WestConnex M4-M5 Link

Rozelle Interchange - Modification: The Crescent overpass and active transport links

Response to submissions report

April 2020

Figure B-10 The revised design - cross sections 1 & 2

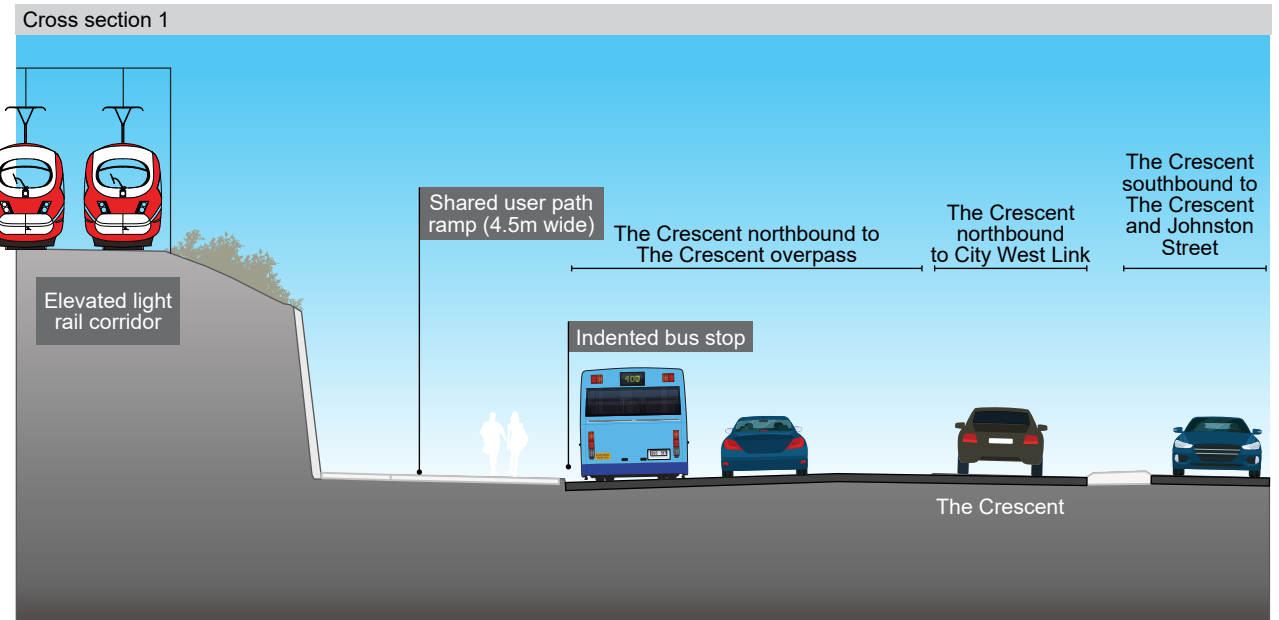
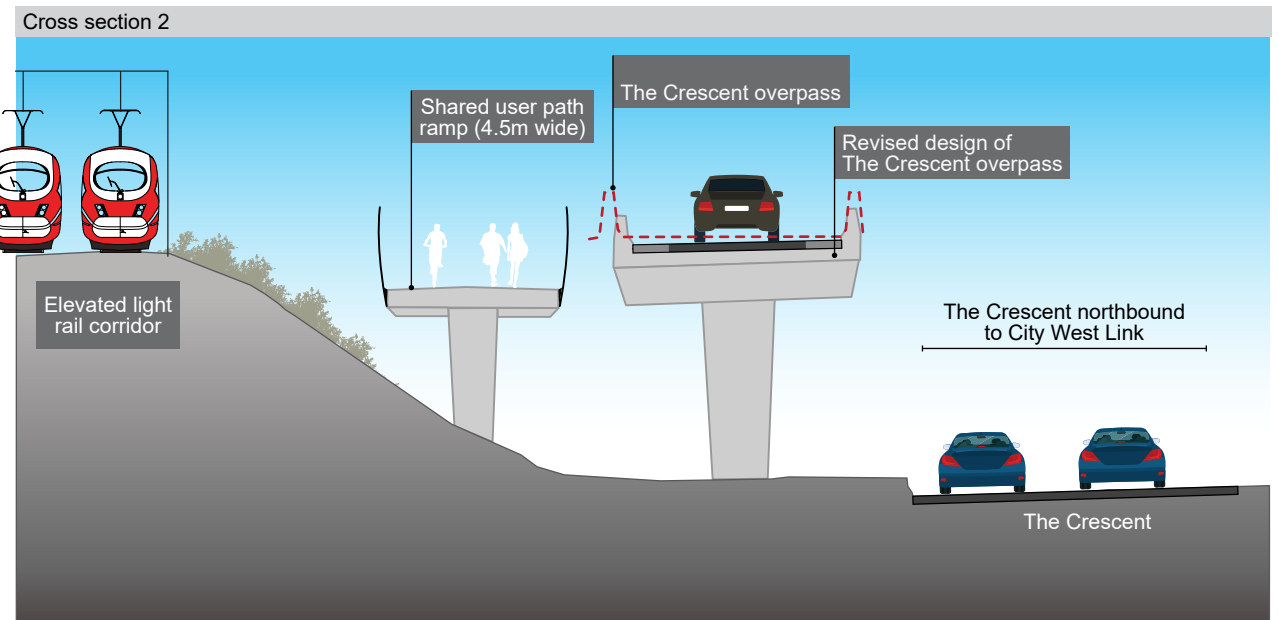
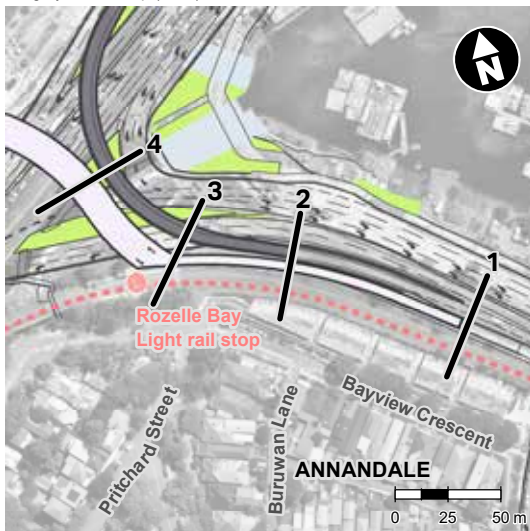
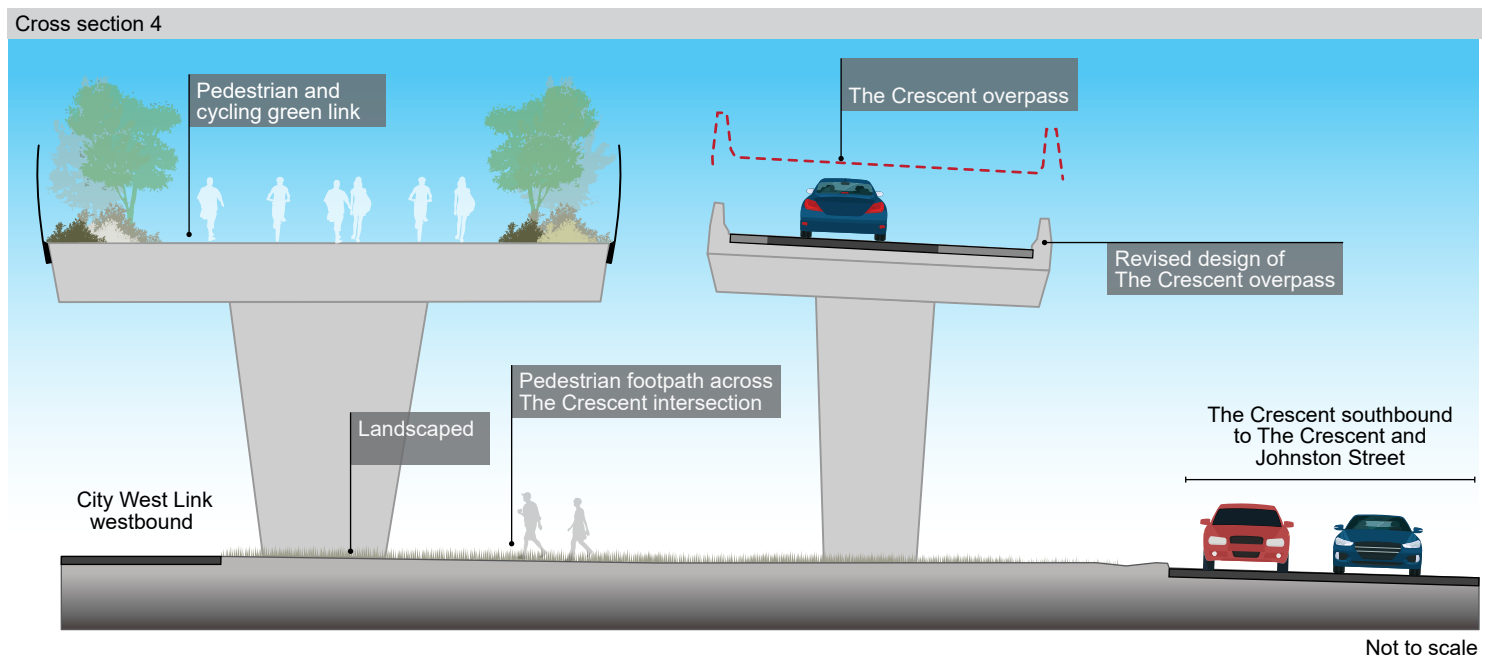
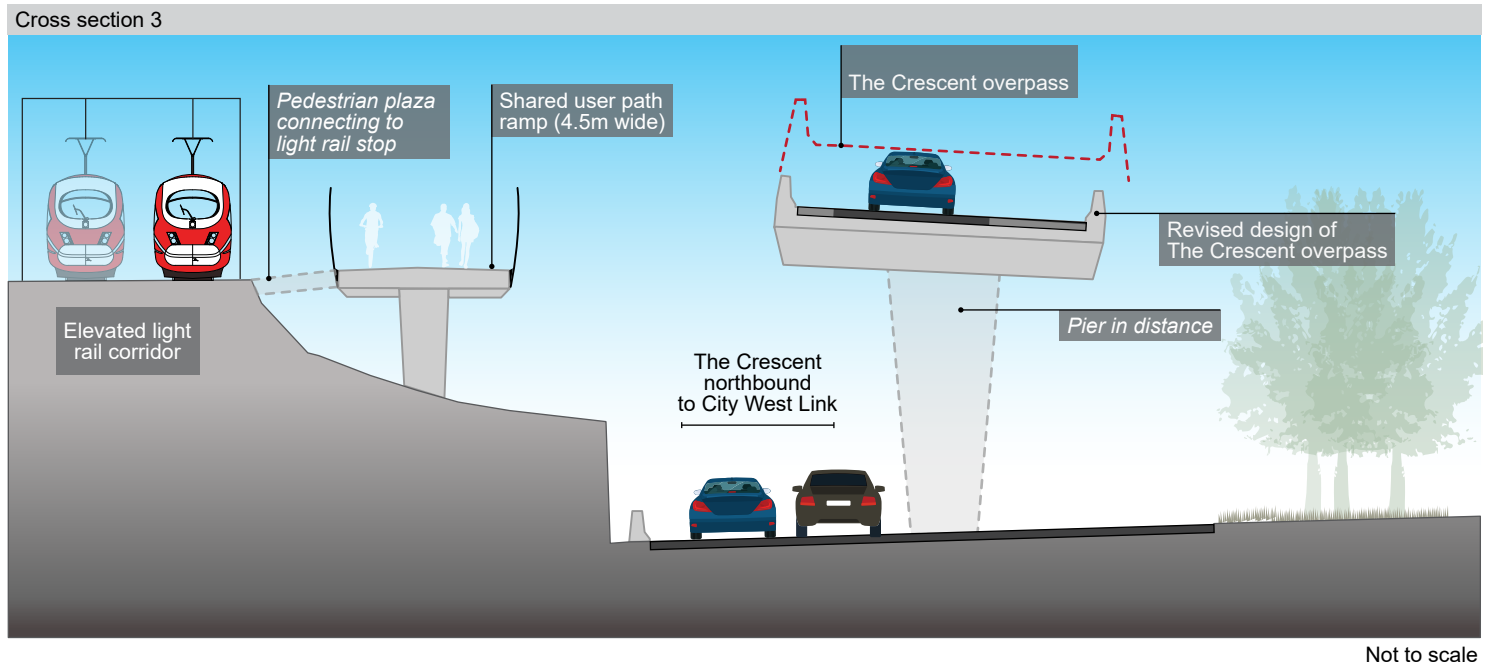
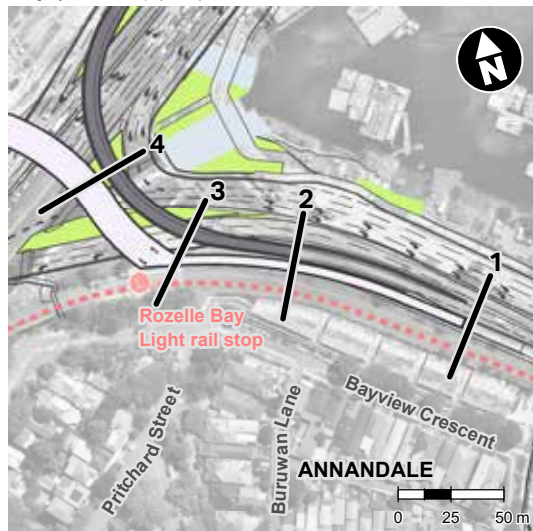
To be consistent with current government policies and best practice the green link should be:

- *Separated for users walking and riding*
- *Have at least three metres for the cycleway*
- *Have at least three metres for the footpath*
- *Have some separation between the cycleway and the footpath.*

Condition E134 requires the preparation of an Urban Design and Landscape Plan(s) in consultation with the relevant council, Infrastructure NSW (former UrbanGrowth NSW), the community and affected landholders and businesses. In preparing this Plan feedback from each of those parties will be considered in finalising the design for the active transport links.
